Private Plan Change Request 28 - Maitahi Bayview Response to Request for Further Information

20-Aug-21

Maitahi Bayview PPCR
Wastewater and Water Supply
Addendum Report

Figure 1 – Walters Bluff wastewater assessment

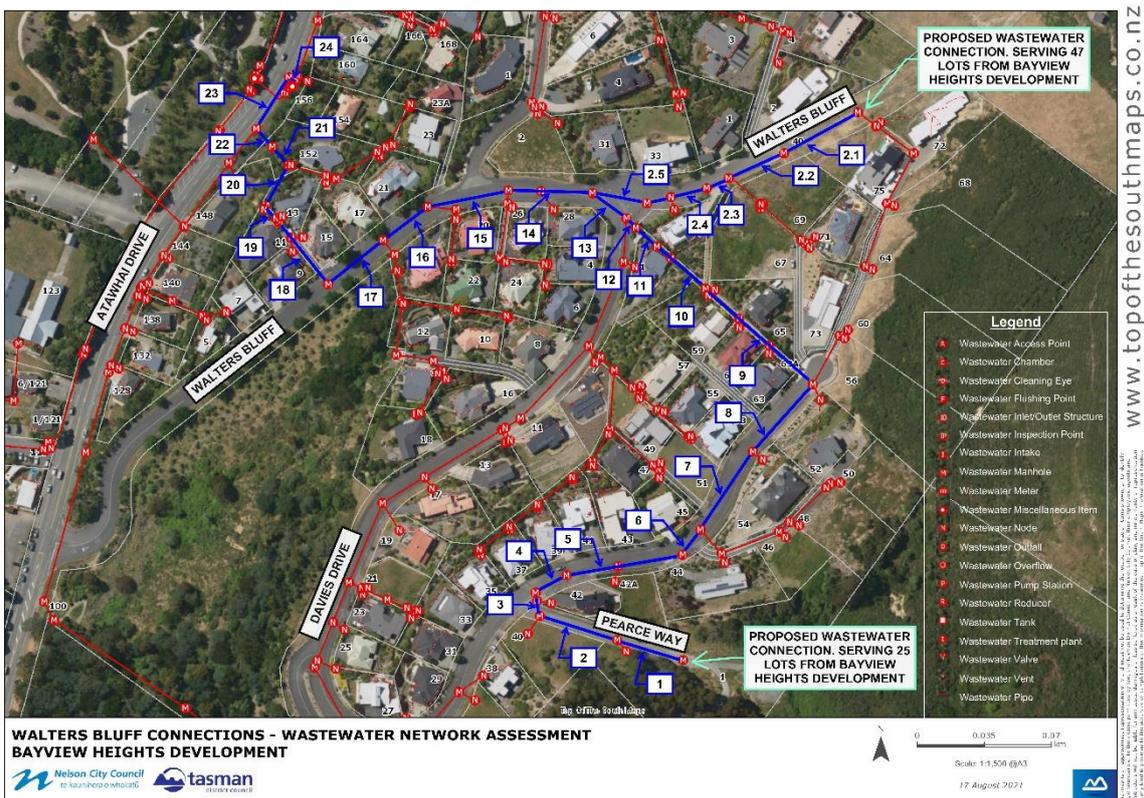
39. Please provide the technical information that demonstrates the adequacy of the capacity of the downstream network on the Walters Bluff and Brooklands side of the development (including for a fully developed catchment area). Alternatively, please address other options.

The proposed wastewater connection point for the Walters Bluff network, and the pre and post development downstream network capacity assessment results for this connection point are shown in Figure 1. This indicates that the existing wastewater network from Walters Bluff to the Cemetery Pump Station at 156 Atawhai Drive C (NCC ID: SO6) has sufficient capacity to serve the proposed development of 72 lots.

1. Red denotes pipes that are under capacity according to NTLDM requirements.
2. Upper self cleansing velocity limit is 3 m/s (According to building code: E1 Surface Water, referenced in NTLDM).
3. "Post Development" refers to existing wastewater flow + additional wastewater flow from 25 residential units through pipes 1-13, 47 units through pipes 2.1-2.5, and 72 units through pipes 14-24.

Figure 2.2 - Option 1 - Proposed rising main along eastern edge of Botanical Hill Reserve

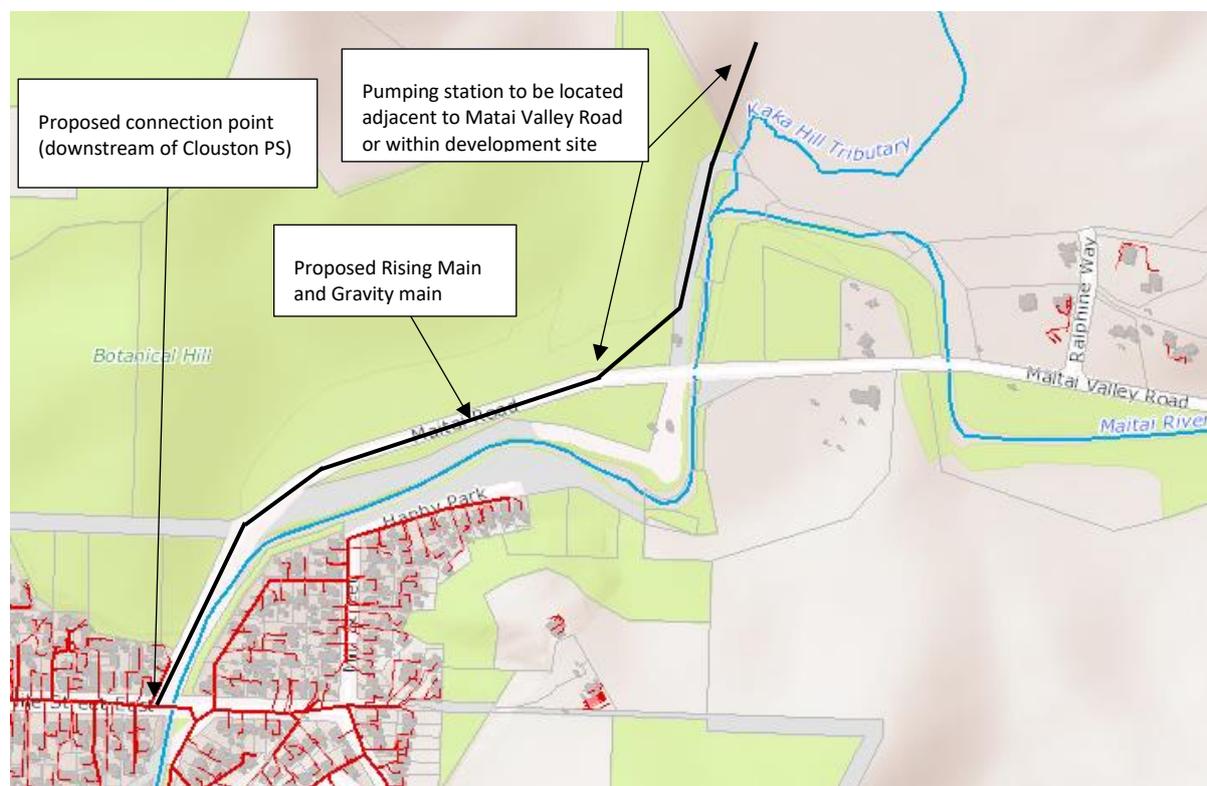
38. Please provide the technical information that demonstrates the suitability of the upgrades that are described as necessary for the connection to the NCC wastewater network in Nile Street through to Neale Park Pump Station. This should include assumptions made around other growth occurring in that catchment (including any changes to inflow and infiltration that have been allowed for) and pipe alignments proposed. The information should address the capacity of the Weka Street/Sovereign Street Pump Station and its rising main to Neale Park Pump Station and the availability of suitable land for the additional storage upgrade identified as required. Please also include consideration of septicity issues arising from the additional pumping steps.

This option consists of extending the wastewater network from Nile Street along Maitai Valley Road to the eastern edge of the Botanical Reserve, along the Dennes Hole walking track, through to the Development. Utilising the Dennes Hole walking track route avoids two river crossings along Maitai Valley Road. A pumping station will be required either adjacent to Maitai Valley Road or within the Development, with a rising main in Maitai Valley Road through to Nile Street. Our initial investigations indicate that it may be feasible to maintain gravity flow from the Development to Maitai Valley Road, allowing the pumping station to be located adjacent to Maitai Valley Road, which would be the preference. However, this will need to be confirmed as part of further detailed investigations.

Connecting to the downstream gravity pipe network will require upgrading of the existing wastewater line to accommodate the additional flow from the Development.

To upgrade the existing wastewater line to accommodate approximately 350 lots would typically consist of replacing all the 150 mm pipes with 300 mm pipes and replacing the last section of 375 mm pipe (which is laid at a very shallow grade) to 450 mm.

Figure 3.3 - Potential reservoir locations

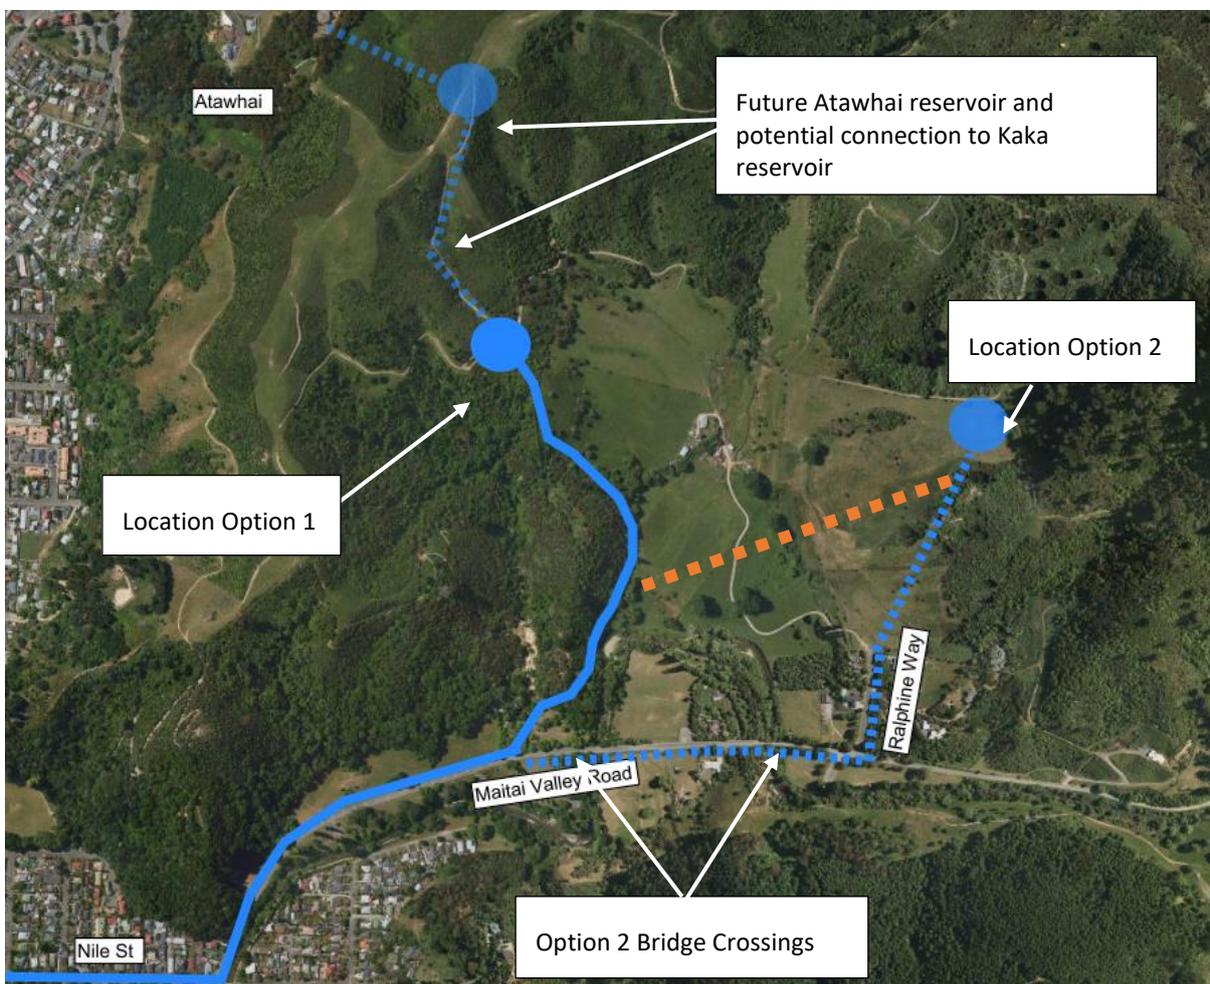
41. *Please provide information that demonstrates the feasibility of the reservoir sites. This needs to include confirmation that the level of the lower reservoir is suitable for it to be filled without pumping from the existing network and that the height and extent of any structure and associated earthworks that would be required could meet the proposed provisions of the PPC itself.*

Option 1 - The first location is on the west side of the development. The reservoir would be connected to the proposed water main in the Maitai Valley Road, which would be extended north along the eastern edge of the Bradford Park/Dennes Hole path. The major advantage of this location is that it avoids the need for two bridge crossings on Maitai Valley Road, and the reservoir could be relatively easily connected to the future NCC reservoir above Atawhai for resilience (NB the Atawhai reservoir isn't currently part of NCC's long-term plan, and timing of construction is uncertain).

Option 2 - The second option would be to locate the reservoir on the east side of the Kaka Valley. The reservoir could connect to a water main extended along Maitai Valley Road and through Ralphine Way, which includes two bridge crossings. Or alternatively, it could follow the same route as suggested for Option 1 above.

This reservoir location would be more expensive to connect to the future reservoir above Atawhai.
